Access Compliance Report

Public Rights-of-Way

Intersection ID: 20620	Main Street: OLD_REID_RD	Cross Street: WADEBRIDGE_CV	Location:	N
ADA ID: E125AD891E11	Ramp Type: PerpDiag	Initial Pass/Fail: Fail	Overall Compliance: No	Severity Score: 8.75

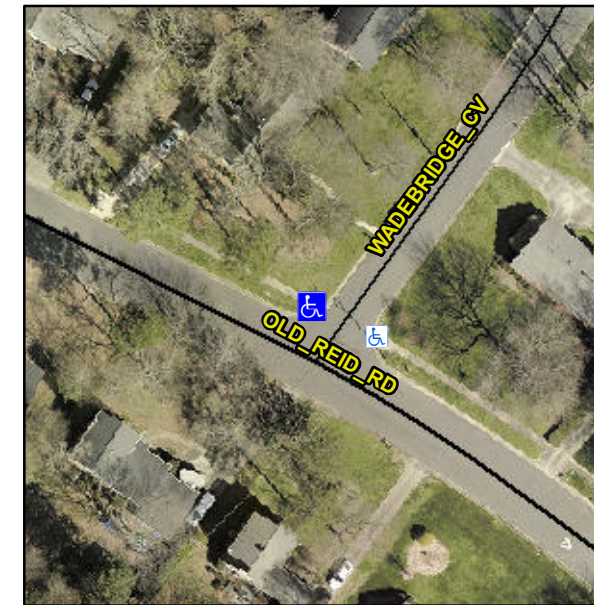
Not Found, R304.5.1

Compliance	Description	Data	Compliance	Description	Data
N/A	Ramp Length (in)	50.0	Yes	Ramp Slope (%)	7.1
No	Ramp Width (in)	47.0	Yes	Ramp XSlope (%)	0.6
N/A	Flare Type LT	N/A	N/A	Flare Type RT	N/A
N/A	Flare Slope LT (%)	N/A	N/A	Flare Slope RT (%)	N/A
N/A	Flare Traversable LT?	N/A	N/A	Flare Traversable RT?	N/A
N/A	Landing Length (in)	N/A	N/A	DWS Provided?	N/A
N/A	Landing Width (in)	N/A	N/A	DWS Contrast?	N/A
N/A	Landing Slope (%)	N/A	N/A	DWS Length (in)	N/A
N/A	Landing X Slope (%)	N/A	N/A	DWS Full Width?	N/A
N/A	Landing Curb? (Y/N)	N/A	N/A	DWS Offset (in)	N/A
N/A	Shared Landing?	N/A			
N/A	Gutter Ponding?	N/A	N/A	Gutter Slope (%)	N/A
N/A	Gutter Lip Ht (in)	N/A	N/A	Gutter X Slope (%)	N/A
N/A	Painted X Walk1?	No	N/A	Painted X Walk2?	No
	X Walk 1 Direction	To SW		X Walk 2 Direction	To SE
N/A	X Walk 1 Width (in)	N/A	N/A	X Walk 2 Width (in)	N/A
	X Walk 1 Slope (%)	2.0		X Walk 2 Slope (%)	2.6
	X Walk 1 X Slope (%)	5.4		X Walk 2 X Slope (%)	2.1

Remove & Replace Curb Ramp With Two New Directional Ramps or Equivalent.
